FINAL DRAINAGE PLAN SF 24X

VILLAGE AT LORSON RANCH

APRIL, 2024

Project No. 100.070

INLET IN A SUMP OR SAG LOCATION

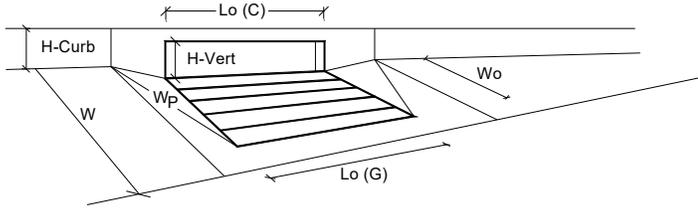
Does flow overtop centerline of road before reaching 6.9 inches of ponding? Flow can bypass over to inlet at DP1a.

INLET IN A SUMP OR SAG LOCATION

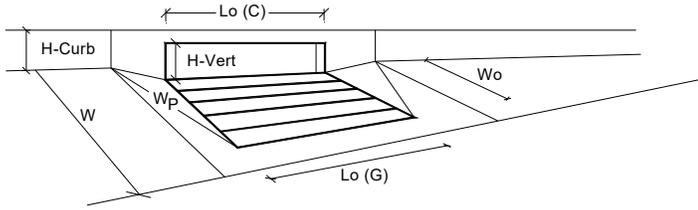
Distance to crown should be half of road width, which is 17'.

INLET IN A SUMP OR SAG LOCATION

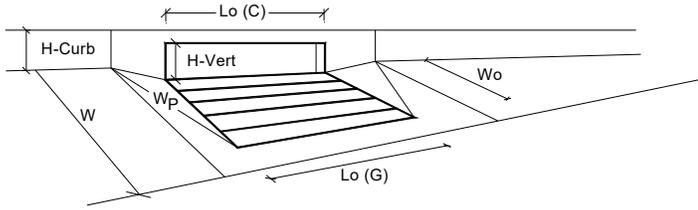
Does flow overtop centerline of road before reaching 7.2 inches of ponding? Flow can bypass over to inlet #3 or make this inlet bigger

INLET IN A SUMP OR SAG LOCATION

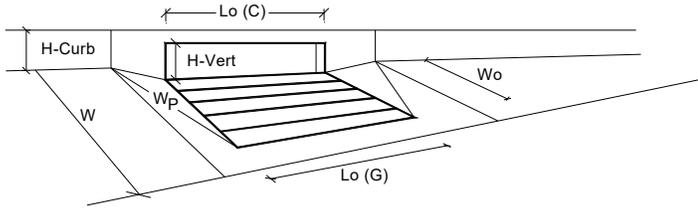
Does flow overtop centerline of road before reaching 6.5 inches of ponding?

STORM SCHEMATIC

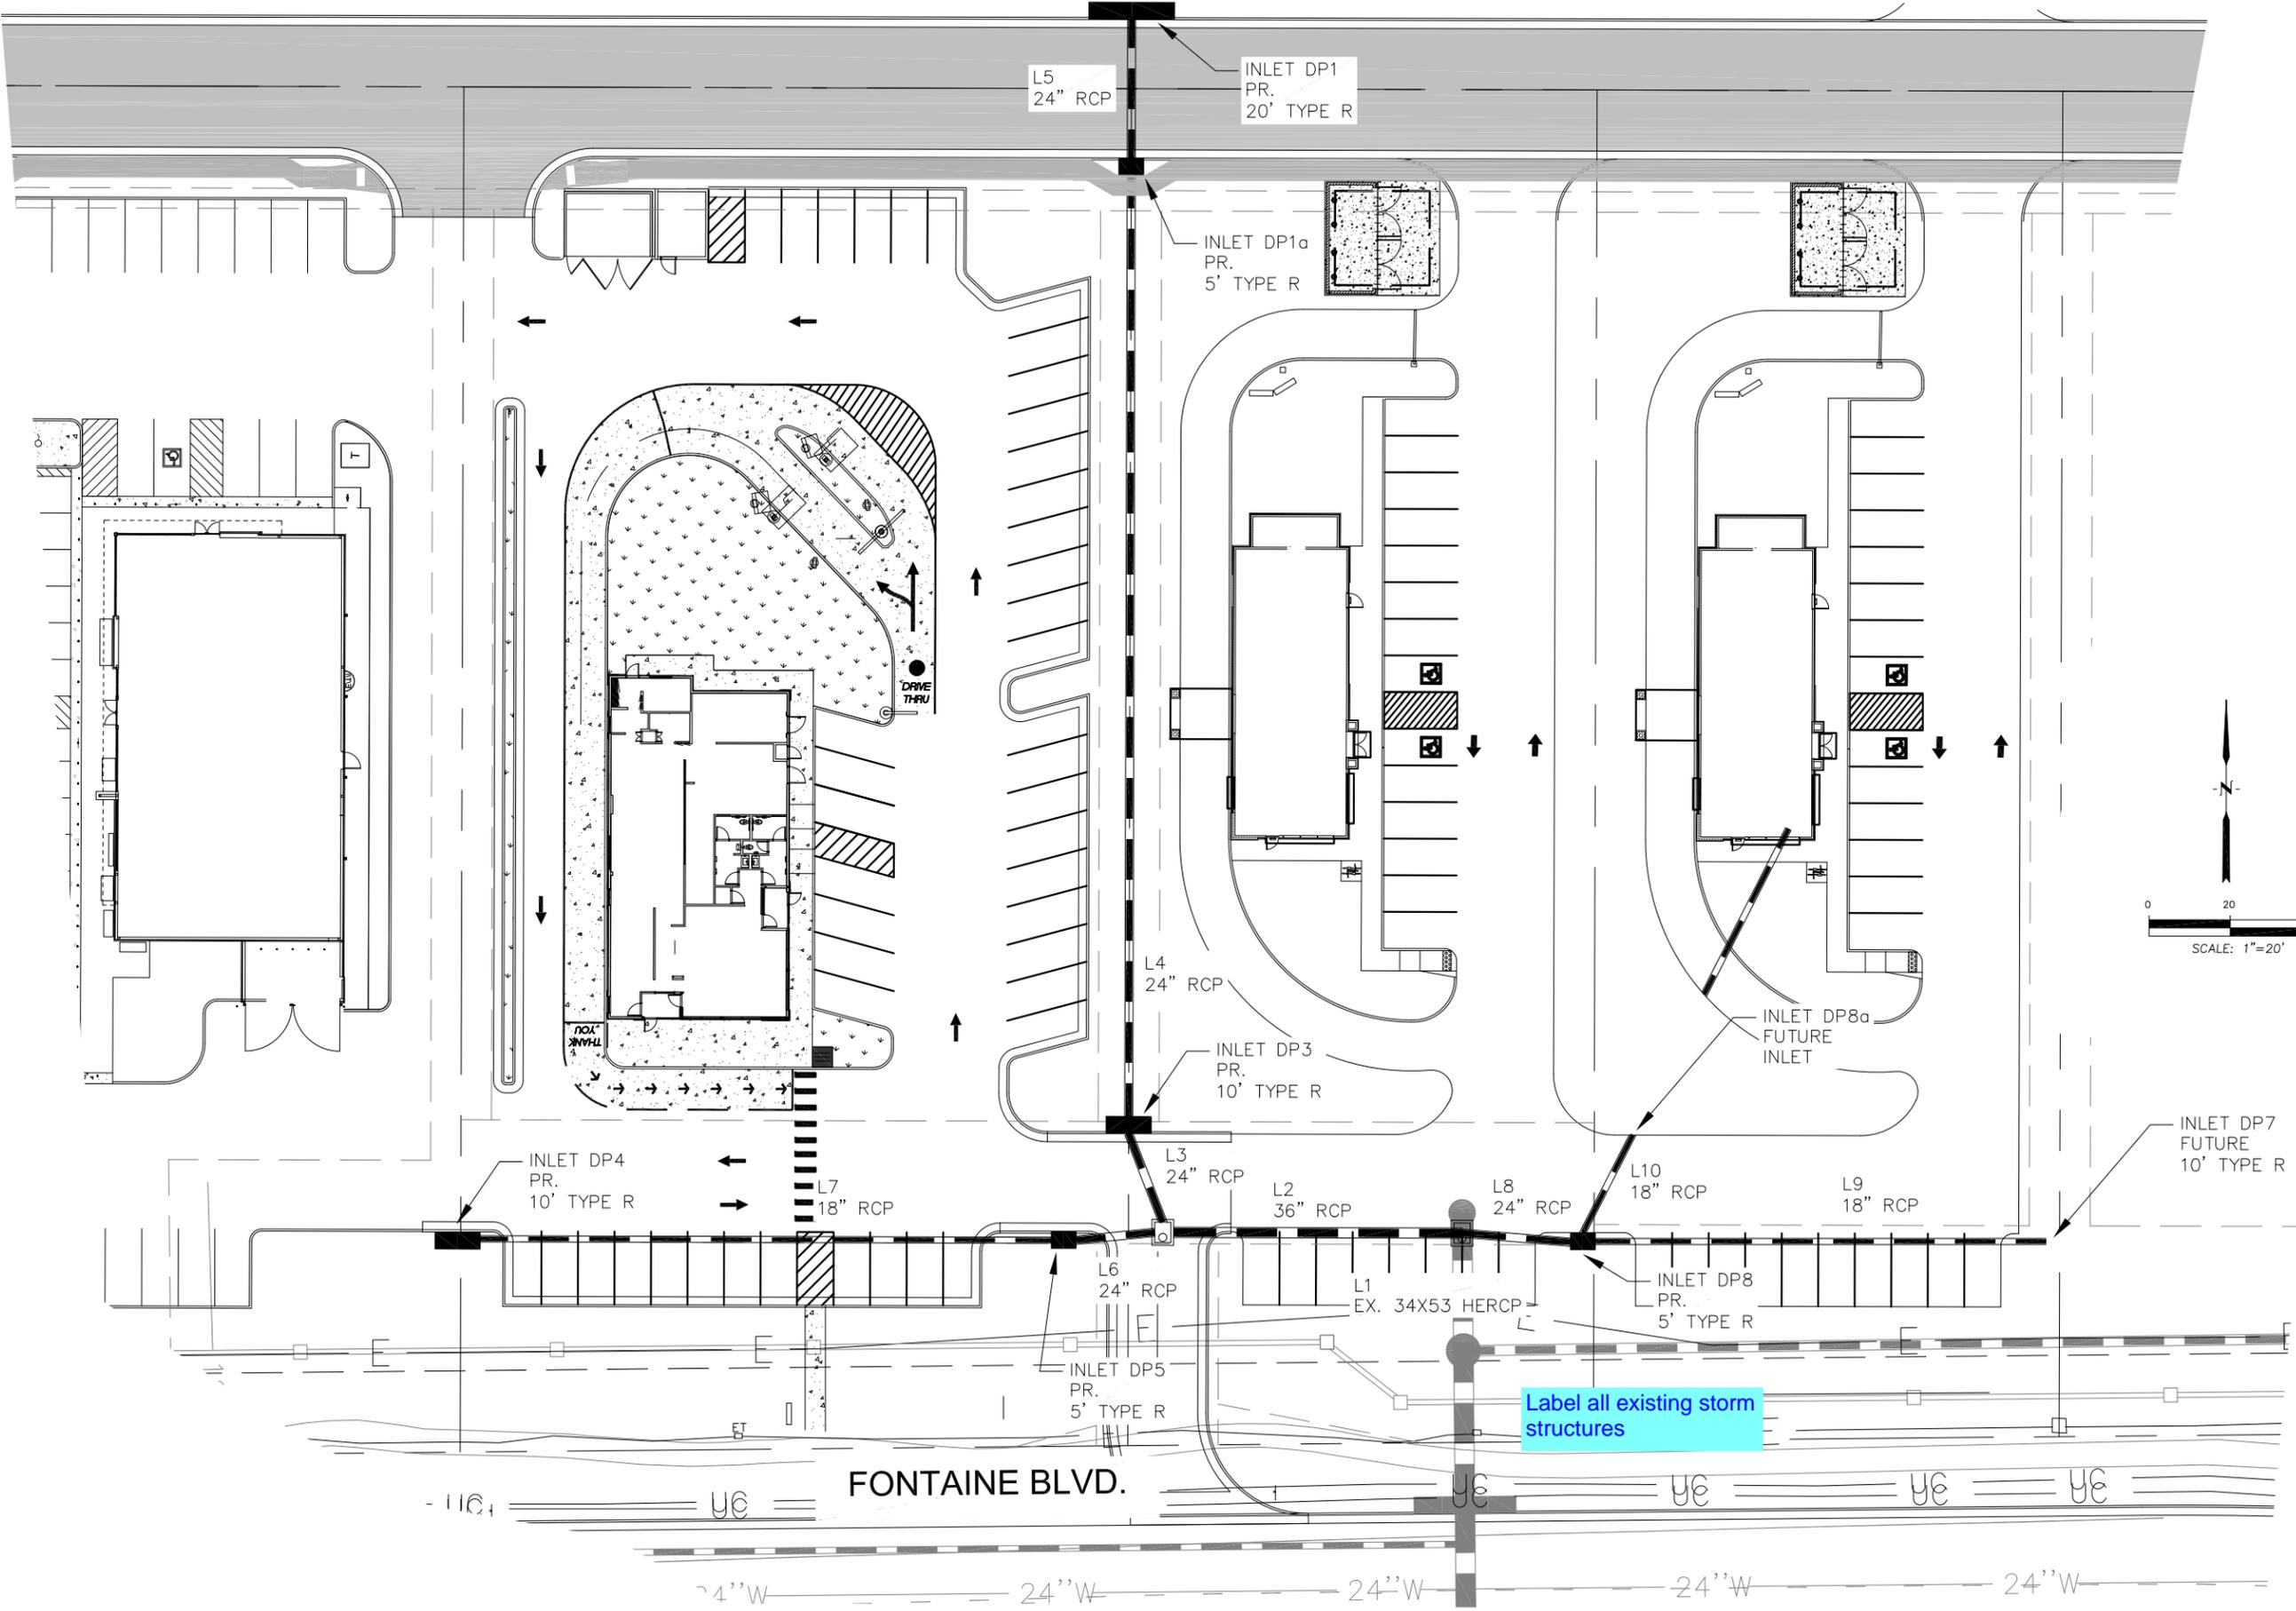
Provide velocities for each pipe in system for 5 & 100 designs.

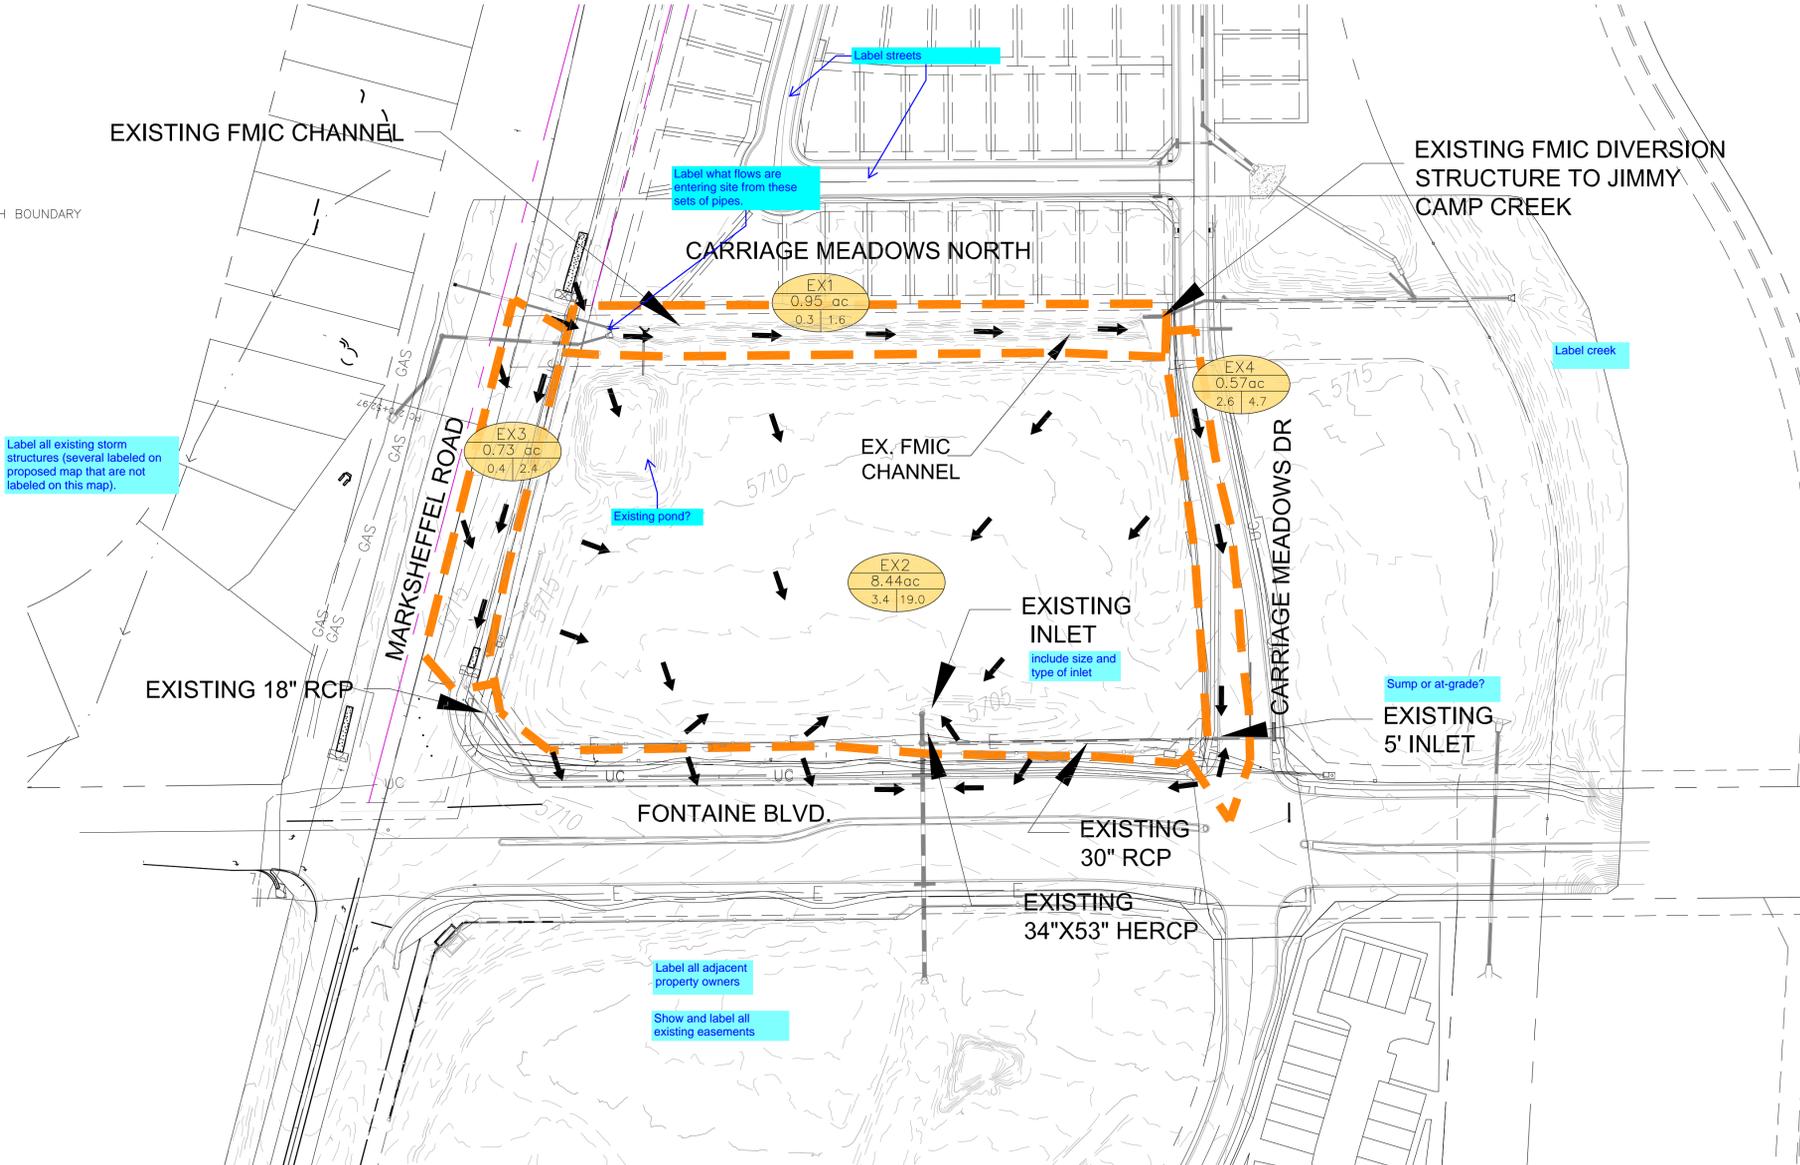
Per note below, HGL is above crown. Revise design to be in pipe or add note to plans.

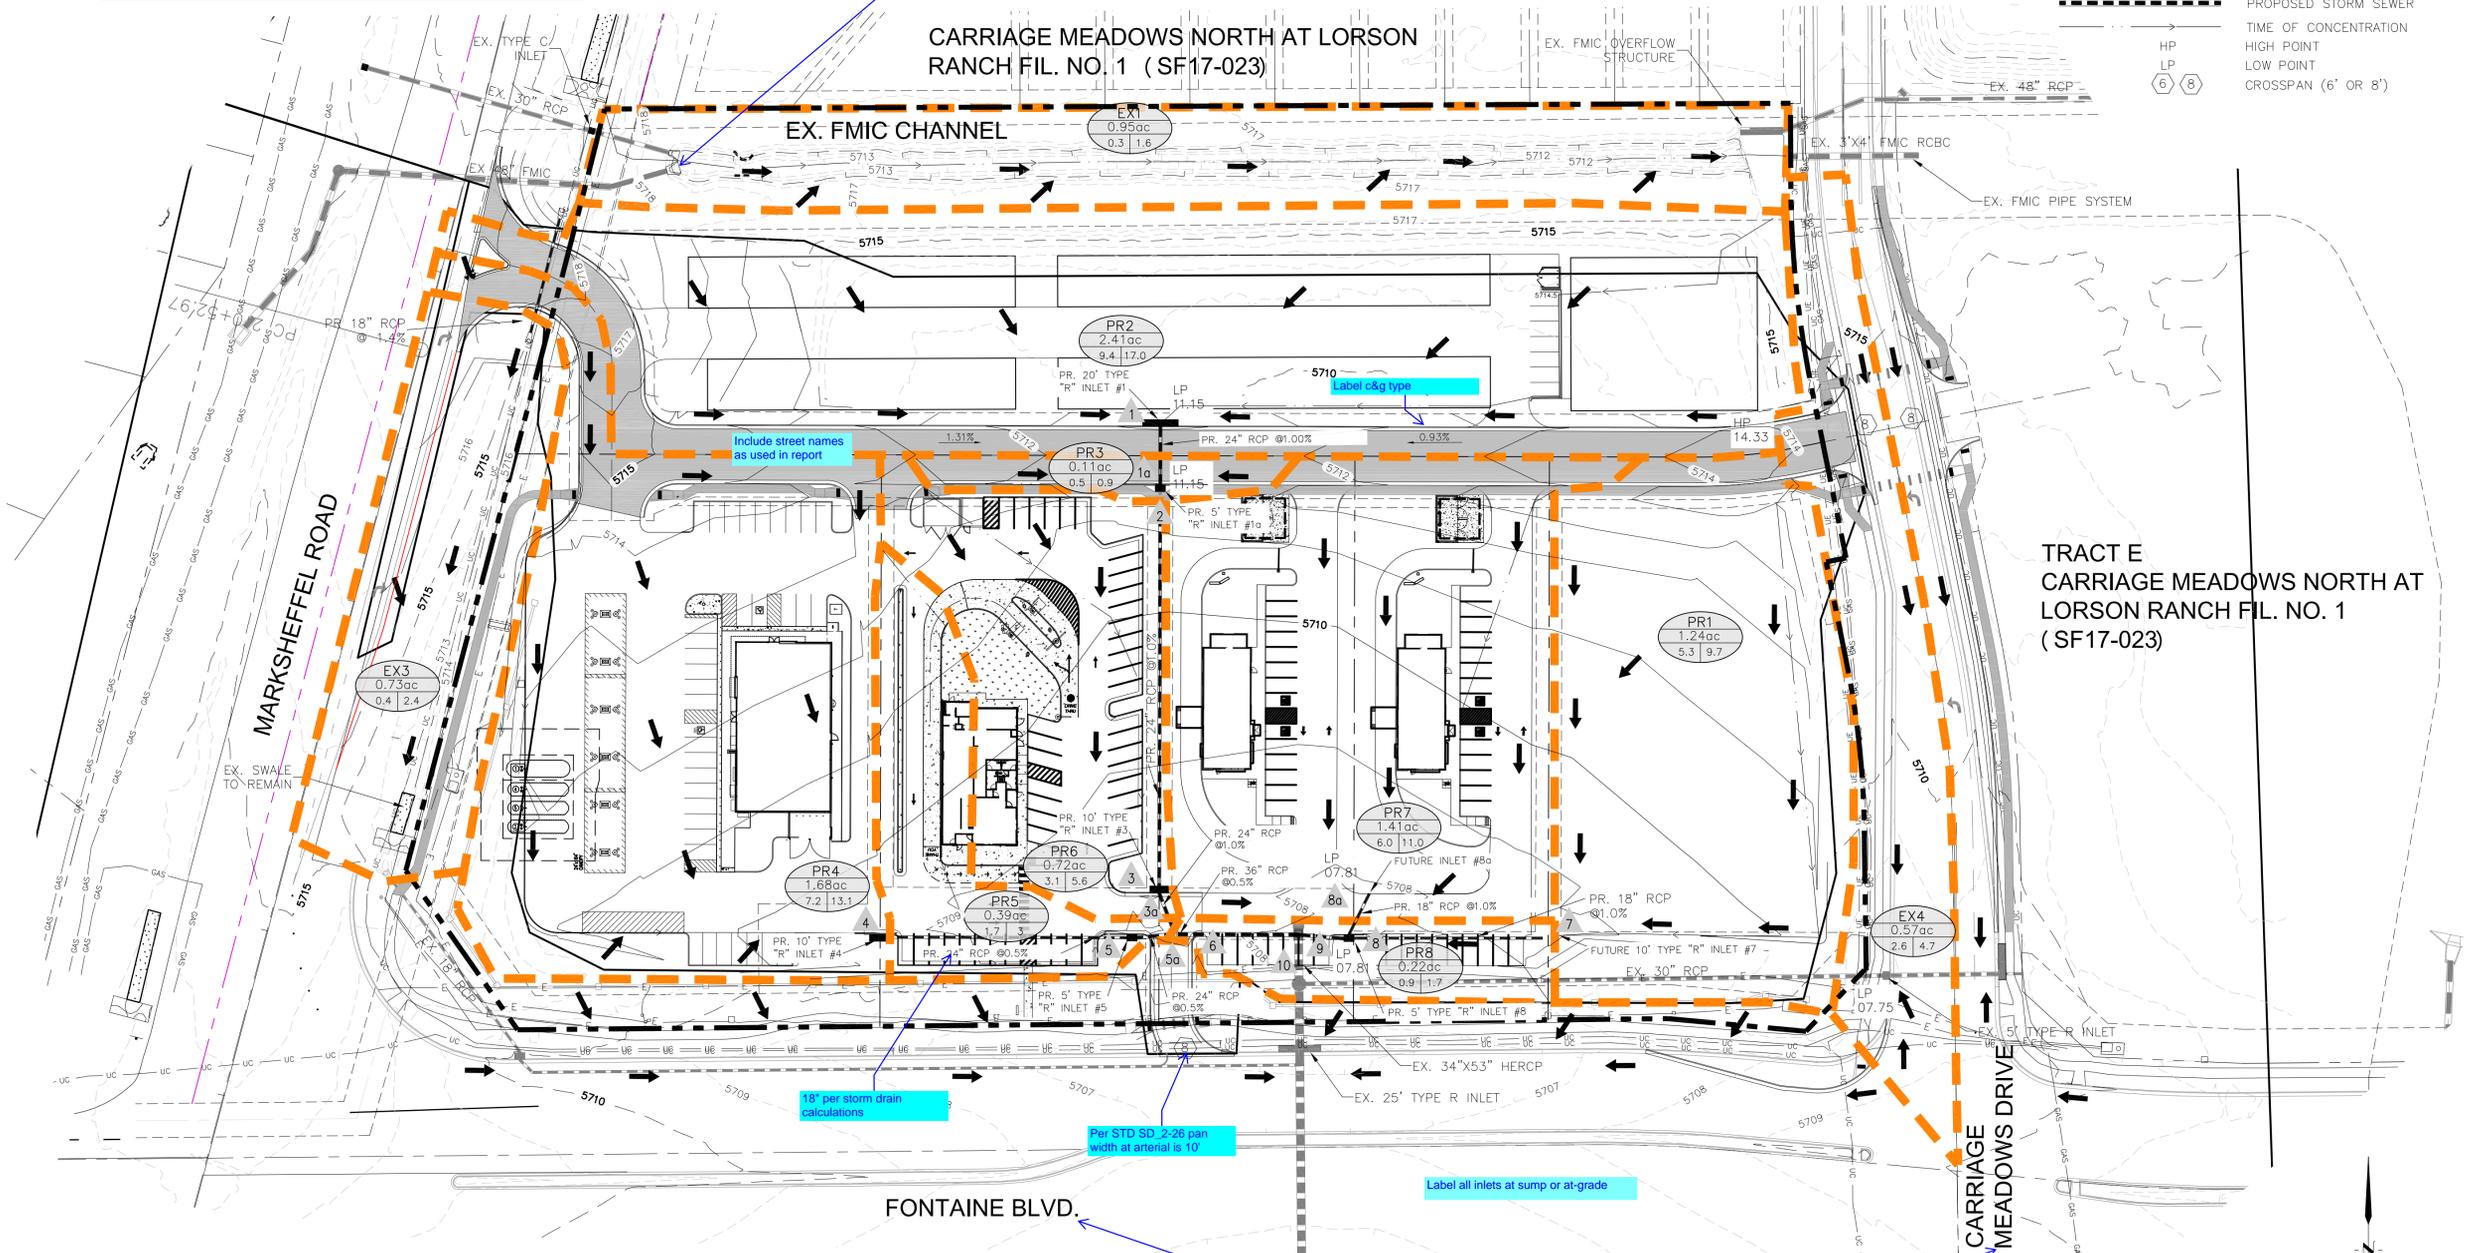
Show and label all existing easements
